**MIL-I-18804B**

Amendment-1

MILITARY SPECIFICATION

INDICATOR. VERTICAL SPEED, 0-6000 FPM, 2-INCH

FIGURE 2. DIAL MARKINGS FOR MS28075-1 (B) and MS28075-2 (B)

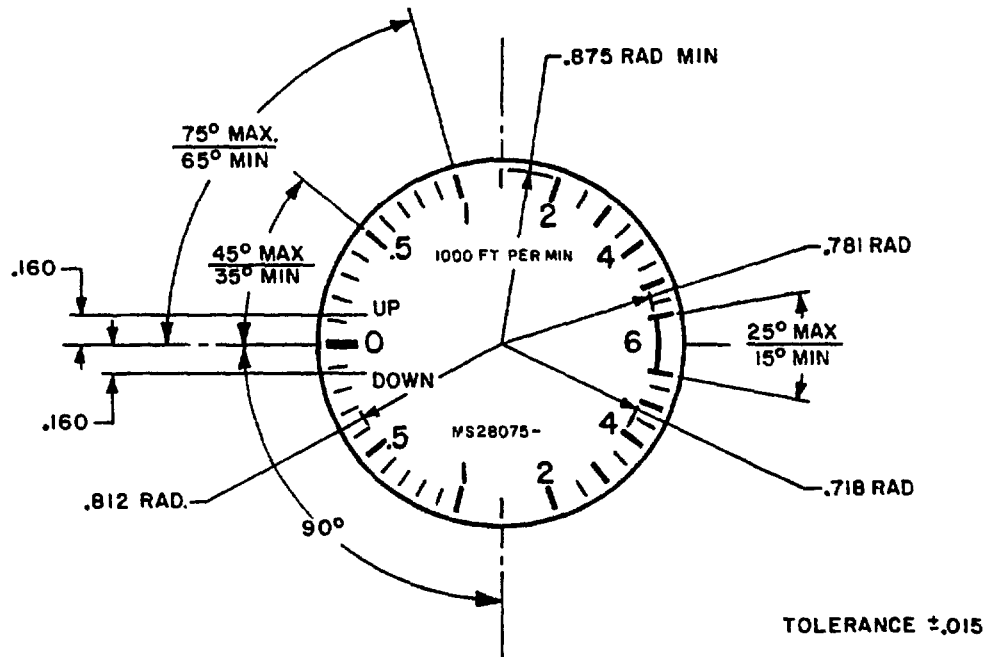
Add Figure 2 "Dial Markings for MS28075-1(B) and MS28075-2(B)" after Figure 1, page 6. Figure 2 forms page 3 of this Amendment.

Page 9, paragraph 4.6.7.1: Delete fourth sentence and substitute "The pointer shall return to zero within 250 FPM in both directions for the Figure 1 dial, and within 150 FPM in both directions for the Figure 2 dial".
